SHINE MEDICAL TECHNOLOGIES, INC.

**SHINE MEDICAL TECHNOLOGIES, INC. PRELIMINARY SAFETY ANALYSIS REPORT
REVISIONS RESULTING FROM REQUEST FOR ADDITIONAL INFORMATION RESPONSES**

**SUMMARY OF PRELIMINARY SAFETY ANALYSIS REPORT CHANGES
PUBLIC VERSION**

**PRELIMINARY SAFETY ANALYSIS REPORT CHANGES
(MARK-UP)**

Figure 12.1-1 – SHINE ~~Functional~~Operational Organization Chart

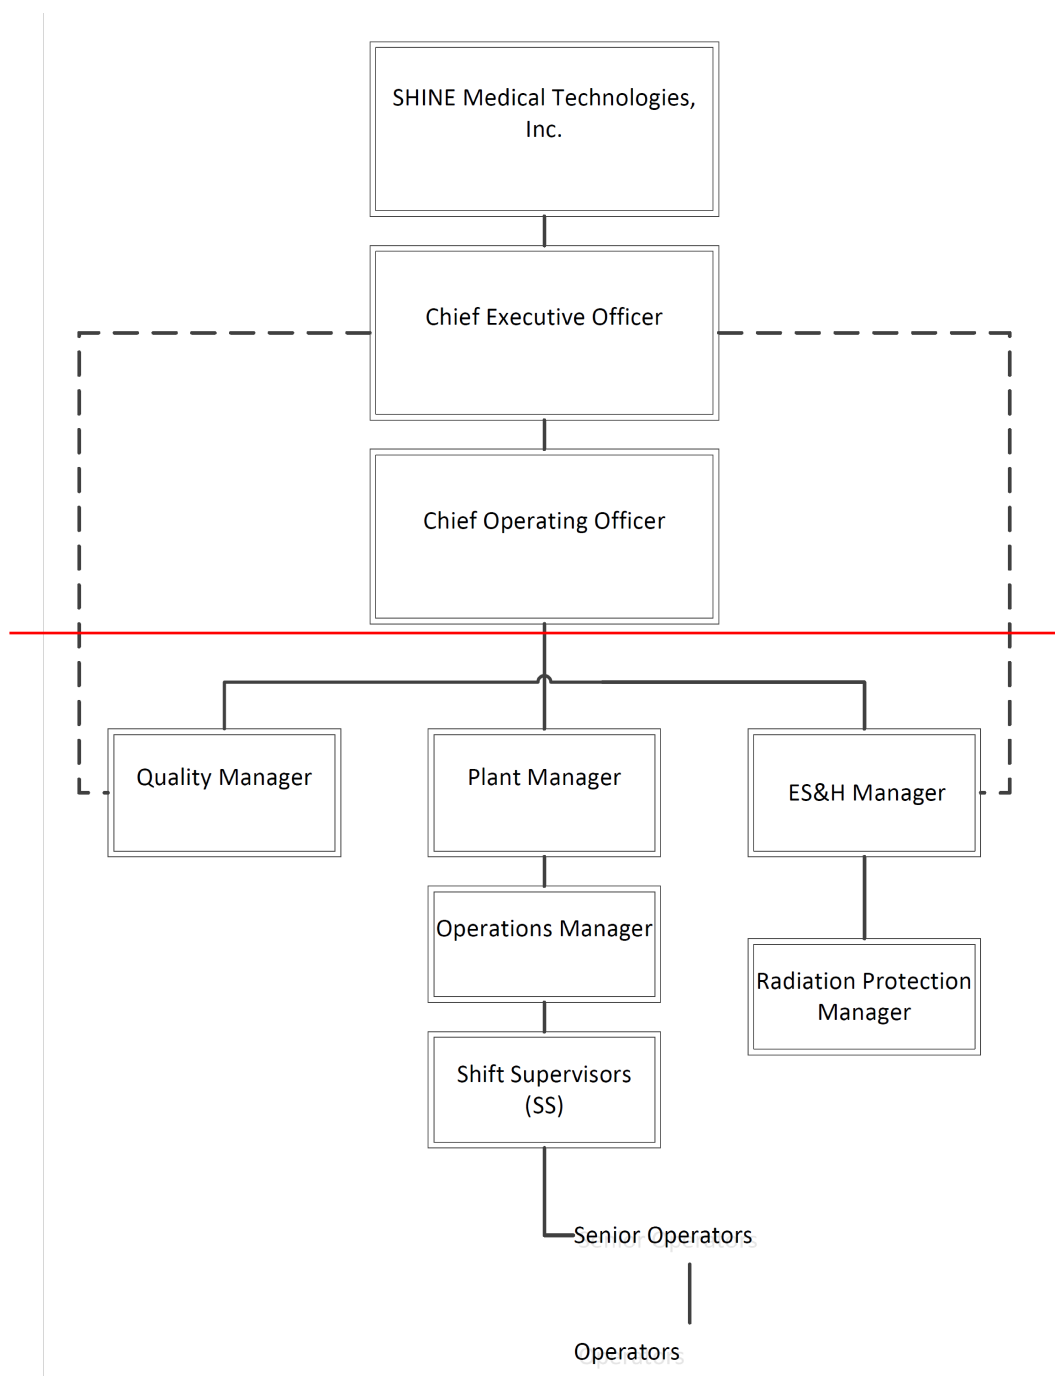
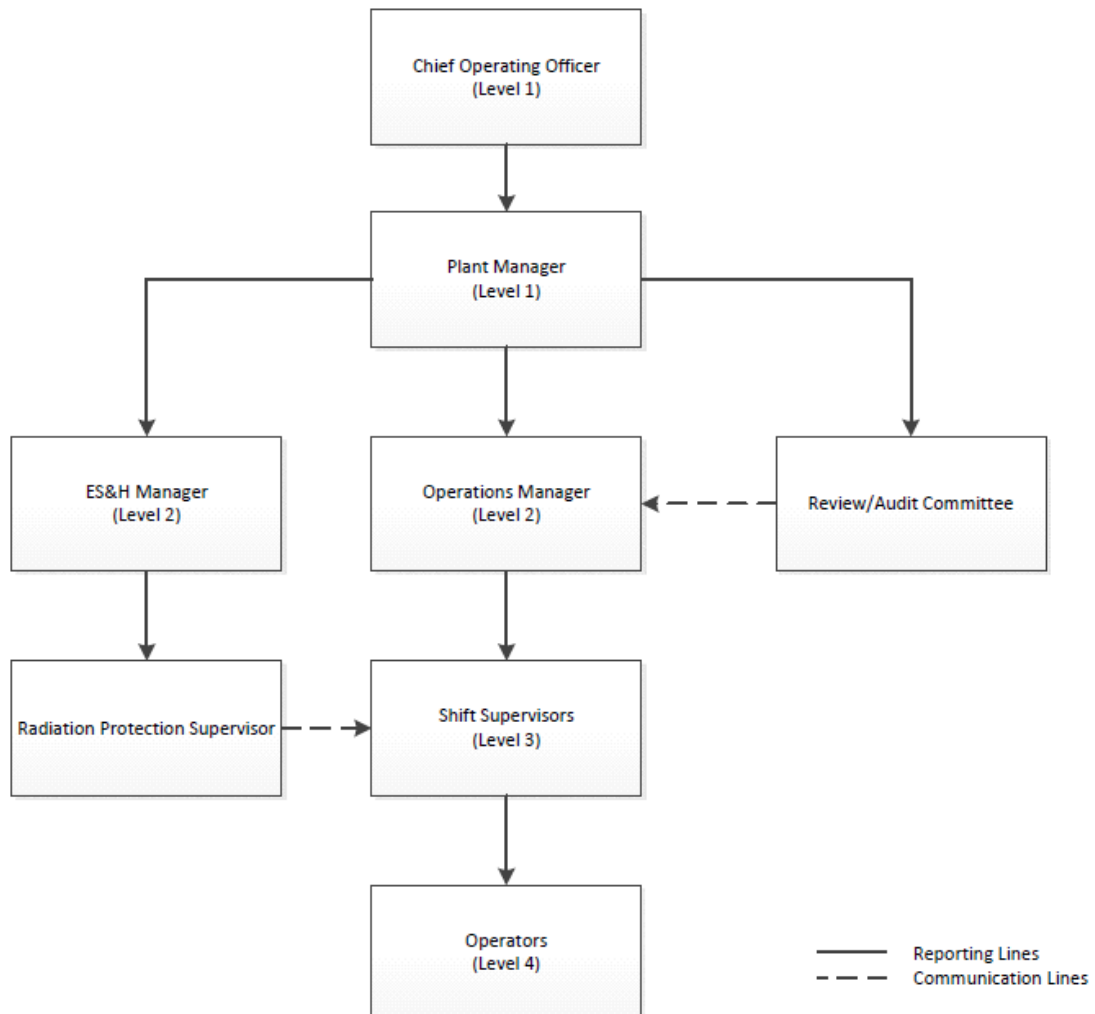
~~The SHINE functional organization is provided in Figure 12.1-1. The staff implementing the radiation safety function supports on-shift plant operations and interacts with Executive Management through the chain of command. The RP Manager reports directly to the Environment, Safety, and Health (ES&H) Manager. The ES&H Manager and the Quality Manager (QM) report to the Chief Operating Officer (COO) and, for independence, have a line of open communication directly to the Chief Executive Officer (CEO). The CEO reports directly to the SHINE Board of Directors. The Operations Manager (OM) and the Training Manager (TM) report to the Plant Manager (PM). The PM reports to the COO. Plant Operators (Level 4) report directly to the Shift Supervisors (Level 3). The RP Supervisor reports directly to the Environment, Safety, and Health (ES&H) Manager (Level 2) and has communication lines with the Shift Supervisors. The Shift Supervisors report directly to the Operations Manager (Level 2). The Review/Audit Committee reports to the Plant Manager (Level 1) and has communication lines with the Operations Manager. The ES&H Manager and Operations Manager report to the Plant Manager. The Plant Manager reports to the Chief Operating Officer (Level 1).~~

~~Manager~~Supervisor, who in turn implements the RP program by supporting ongoing activities in the SHINE facility. The RP program content and implementation are reviewed at least annually, as required by 10 CFR 20.1101(c). Sufficient resources in terms of staffing and equipment are provided to implement an effective RP program. Further details related to the authority of the radiation safety staff with respect to facility operations will be provided in the FSAR.

The organizational structure for the management and operation of the SHINE facility is provided in Figure 12.1-1. SHINE management levels are described as follows:

The ES&H Manager reports to the COO and is responsible for all matters regarding environment, safety, and health, including radiation protection (RP). The ES&H Manager works closely with the QM on matters involving adherence to safety requirements defined in the Quality Assurance Program Description (QAPD) and other federal, state, and local regulatory requirements. The ES&H Manager works with other managers to ensure consistent interpretations of ES&H requirements, perform independent reviews, and support facility and operations change control reviews. The ES&H Manager has the ability and responsibility to report to the CEO any safety issues that cannot be resolved at the COO level.
